Application of QuikTrip Corporation for a Special Land Use Permit (SLUP) to allow a drive-through facility (car wash) in an activity center in the C-1 (Local Commercial) zoning district, at 4733, 4773 and 4775 Memorial Drive.

PETITION NO: N9-2026-0447 SLUP-26-1248016

STAFF ANALYSIS

CASE NO.:	SLUP-26-1248016	File ID #: 2026-0447
Address:	4733, 4773 & 4775 Memorial Dr., Decatur 30032	Commission District: 4 Super District: 6
Parcel ID(s):	18 012 13 033, 18 012 13 015, 18 012 13 001	
Request:	Application of QuikTrip Corporation for a Special Land Use Permit (SLUP) to allow a drive through facility (car wash) in the Town Center character area in the C-1 (Local Commercial) zoning district.	
Property Owner(s):	QuikTrip Corporation c/o Eric Bikas	
Applicant/Agent:	QuikTrip Corporation c/o Eric Bikas	
Acreage:	5.23	
Existing Land Use:	Town Center	
Surrounding Properties:	North: C-1 (Local Commercial) South: C-1, R-100 (Residential Medium Lot-100) East: C-1, R-100 West: C-1	
Comprehensive Plan:	Consistent Inconsistent X

SHEET TITLE:
 SITE PLAN

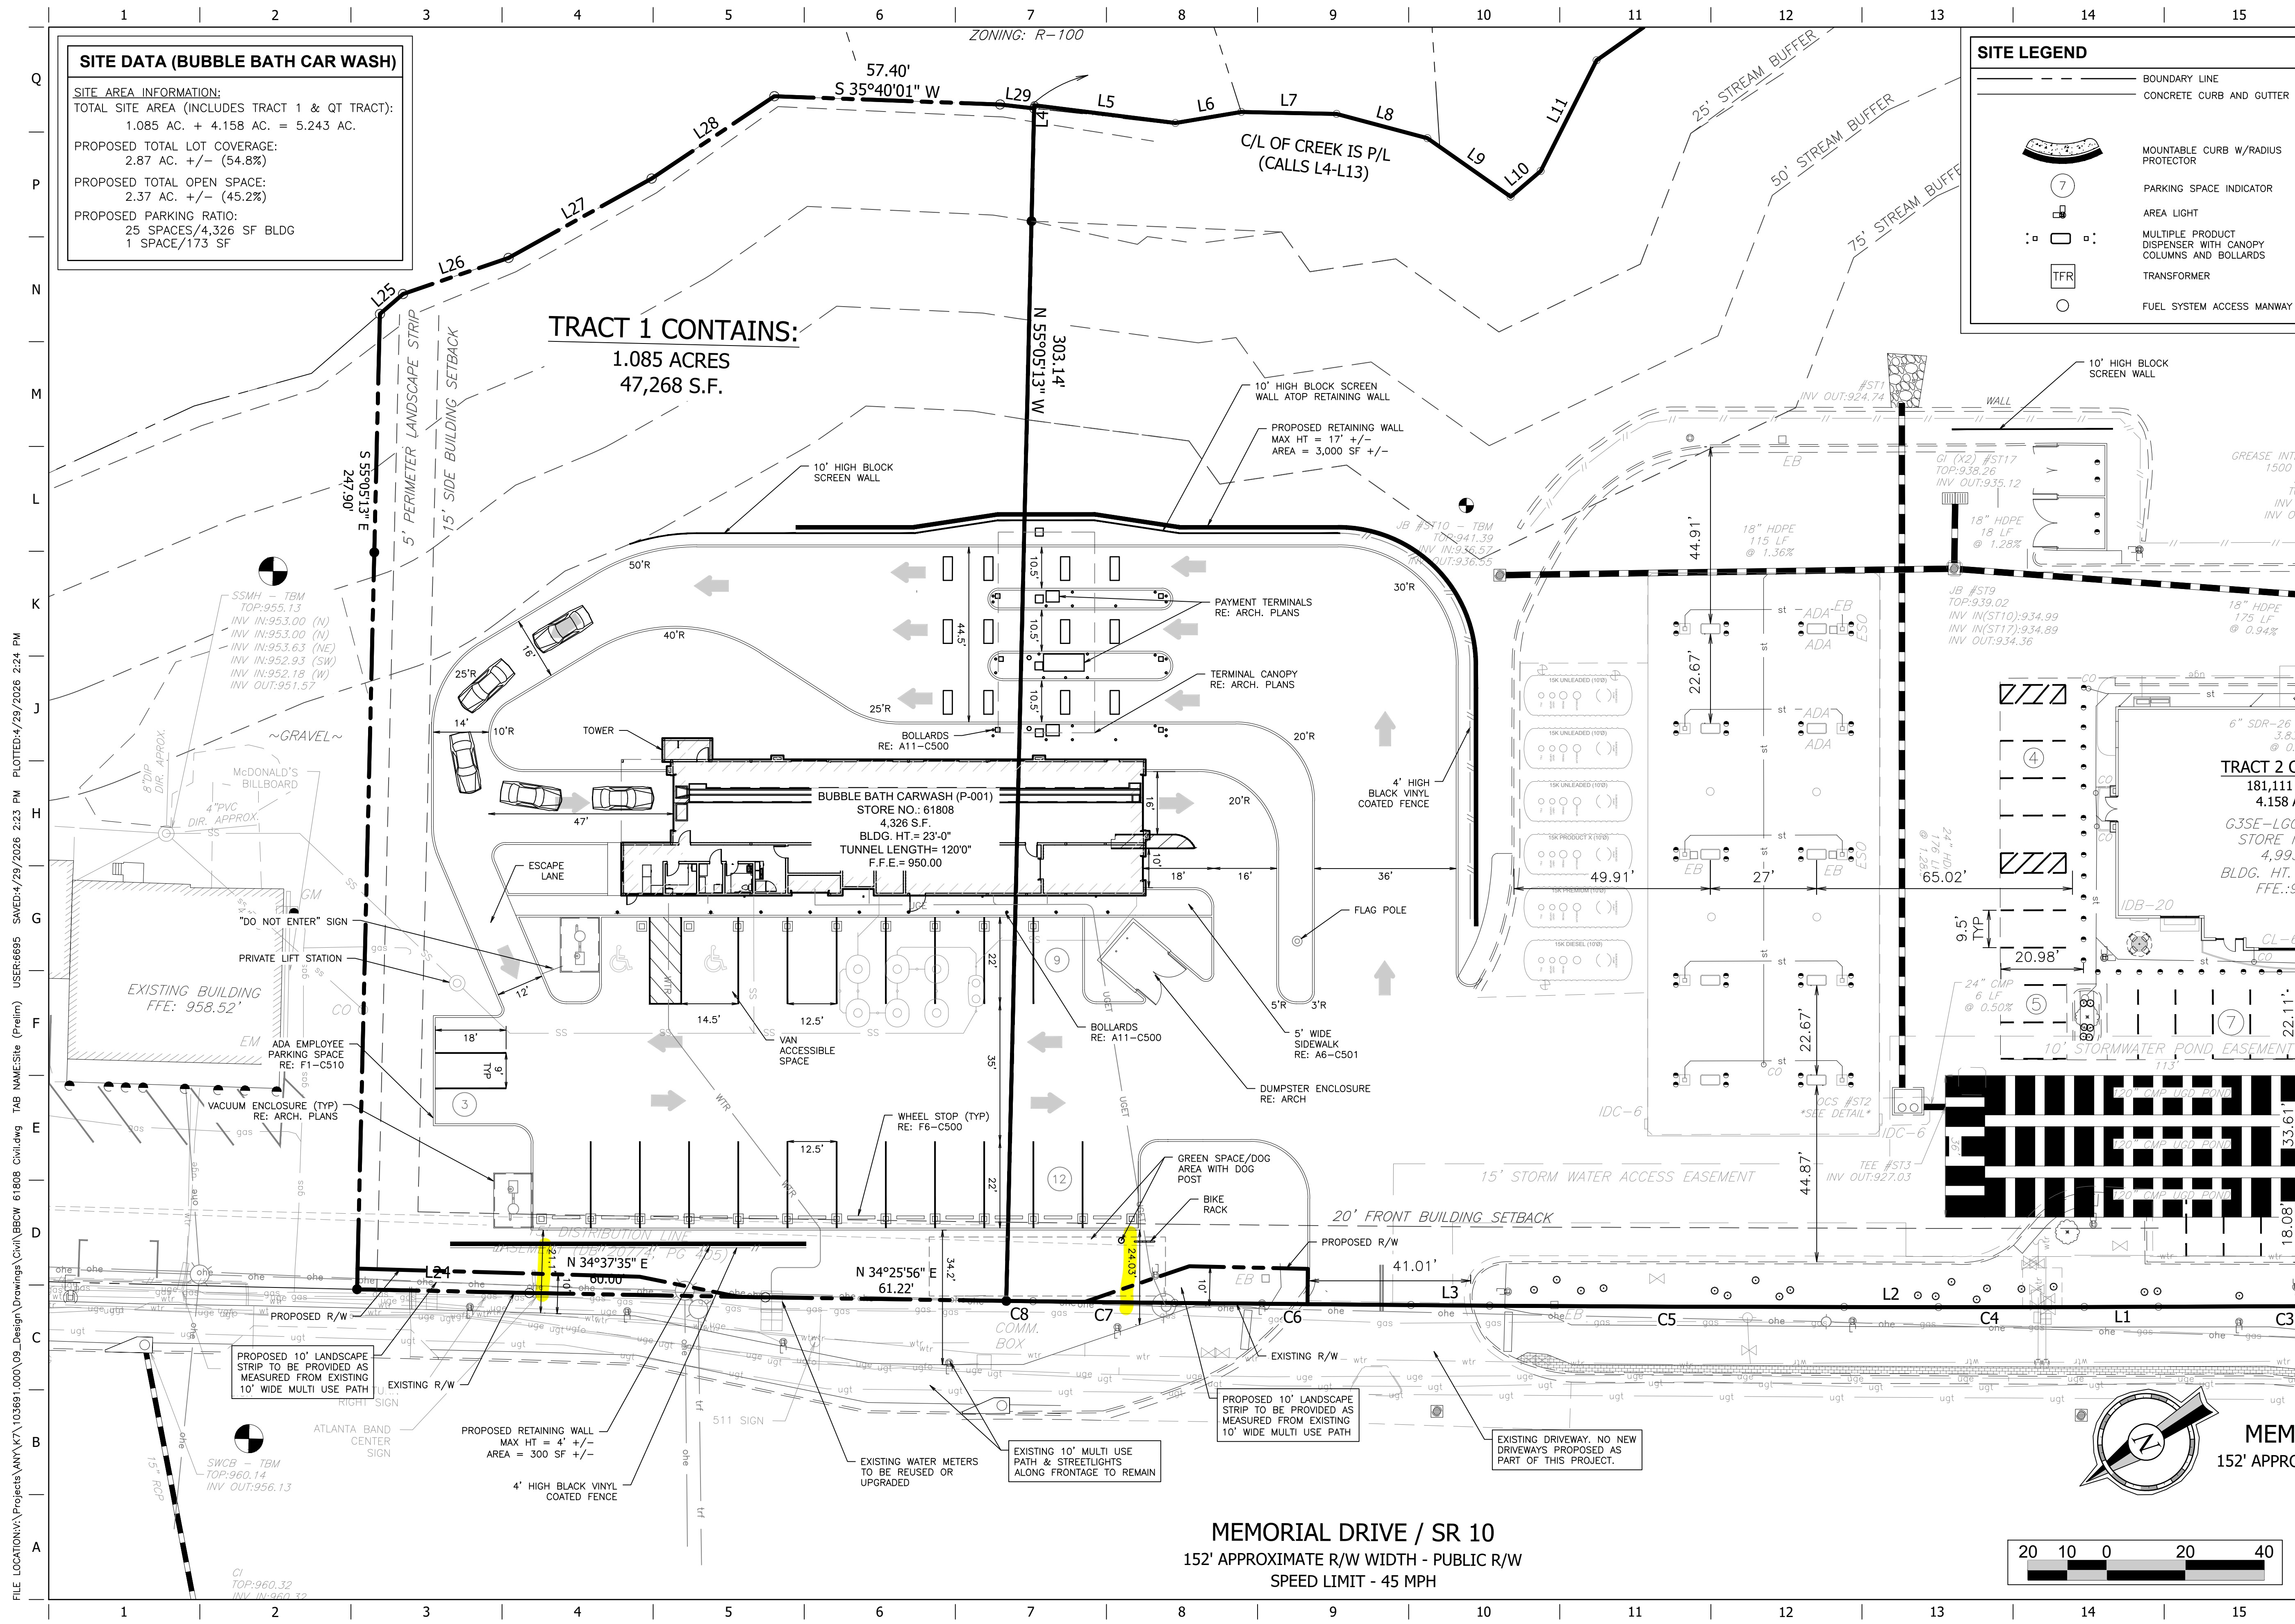
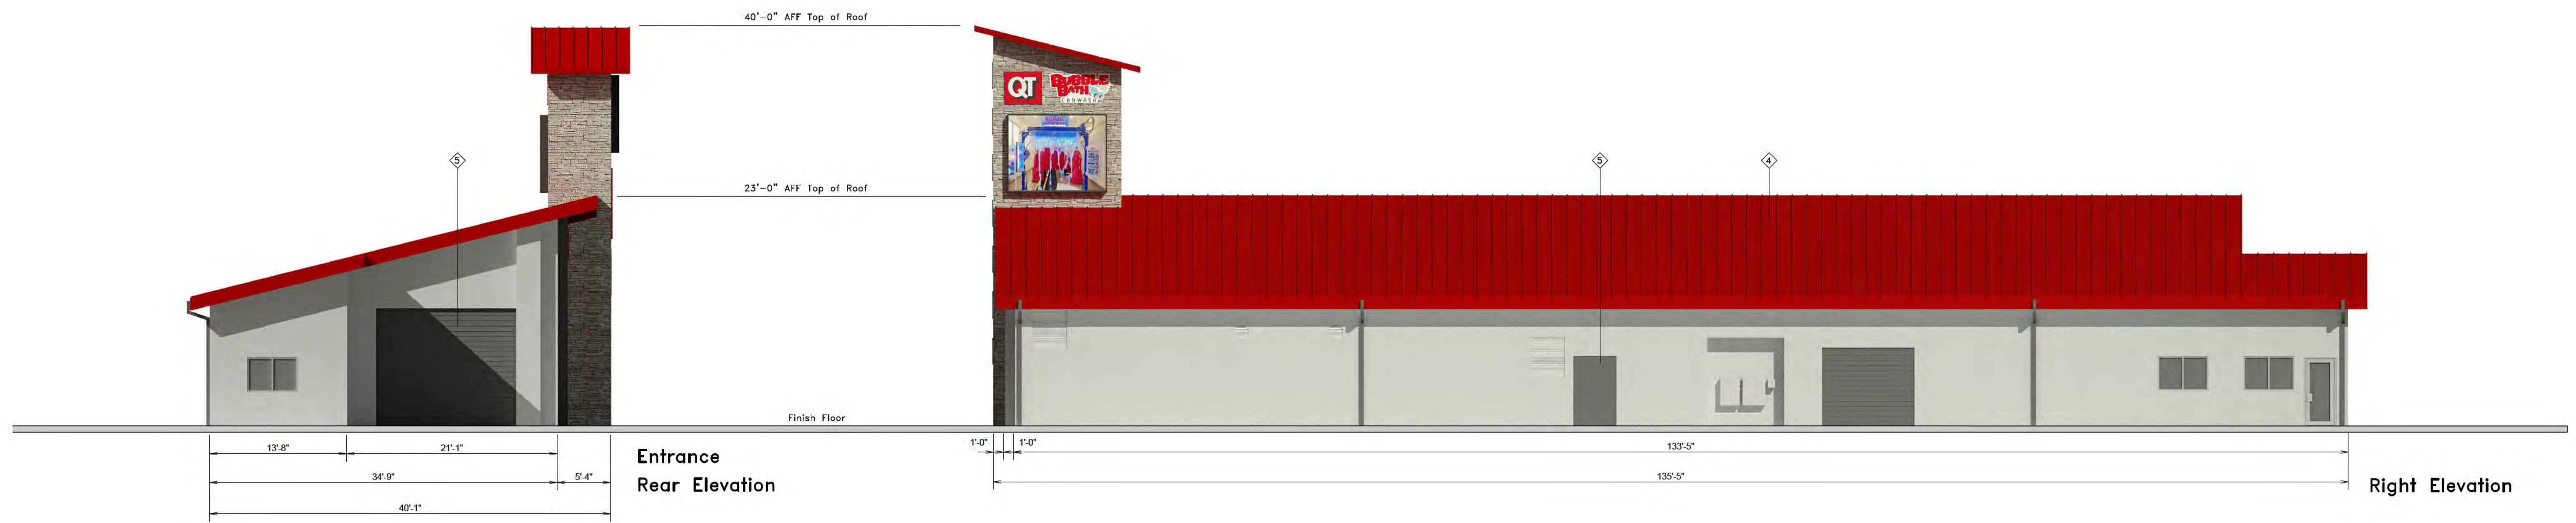
The proposed expansion and assemblage of parcels provide sufficient area to accommodate the use. Based on the submitted site plan “QuikTrip Bubble bath No.61808 Sheet 02” (revised and submitted on 4/22) requirements of Section 2.24.1 (C-1-Dimensional requirements) are mostly met, including: open space (45.2%), 50-foot undisturbed buffer adjacent to the single-family residential neighborhood to the southeast, and Section 6.1.5 (Off-street parking). The Applicant has stated two (2) variances will be sought; 1) Front building setback variance (20ft-60ft is allowed, proposed 103 ft +/-); and, 2) Wall height variance (12ft is allowed, proposed 16ft-17’ once the final wall plans are produced. The applicant did not display compliance with the Supplemental Regulations in Section 4.2.13 (A) required queuing capacity, it appears to be adequate. Additionally, Section 5.4.3 (Streetscape elements and dimensions) sidewalk dedication and

landscape strip (Table 5.1 specifies 20ft is required) are not displayed per submitted landscaping plan “*QuikTrip Bubble bath No.61808 Sheet 04*”. The site fronts Memorial Drive, a Major Arterial and Georgia State Route (Transportation Division comments enclosed). Proposed hours of operation are 8:00 AM to 7:00 PM in winter and 8:00 AM to 9:00 PM otherwise, with no overnight operations. The enclosed tunnel design is expected to minimize external impacts.

1. As shown on the site plan “*QuikTrip Bubble bath No.61808 Sheet 02*” (revised and submitted on 4/22/2026) the subject site will be developed to minimize impacts to adjacent properties, including:

- Orientation of vacuum and service areas will be located between the proposed building and Memorial Drive;
 - Maintenance and/or enhancement of existing tree buffers adjacent to residential properties to the southeast of the subject site;

- Placement of refuse and service areas will be located between the proposed building and Memorial Drive and screened in accordance with County standards.

3. Prior to issuance of land disturbance permits, the applicant shall revise the site plan “*QuikTrip Bubble bath No.61808 Sheet 02*” (revised and submitted on 4/22/2026) to demonstrate full compliance with Section 5.4.3 (*Streetscape elements and dimensions*), including required sidewalks, landscape strips, streetlights, and street trees along Memorial Drive.

4. The site plan “*QuikTrip Bubble bath No.61808 Sheet 02*” (revised and submitted on 4/22/2026) shall enhance pedestrian connectivity between the public sidewalk along Memorial Drive and building entrances, including clearly defined walkways and connections to the outdoor seating and any greenspace areas (if provided).
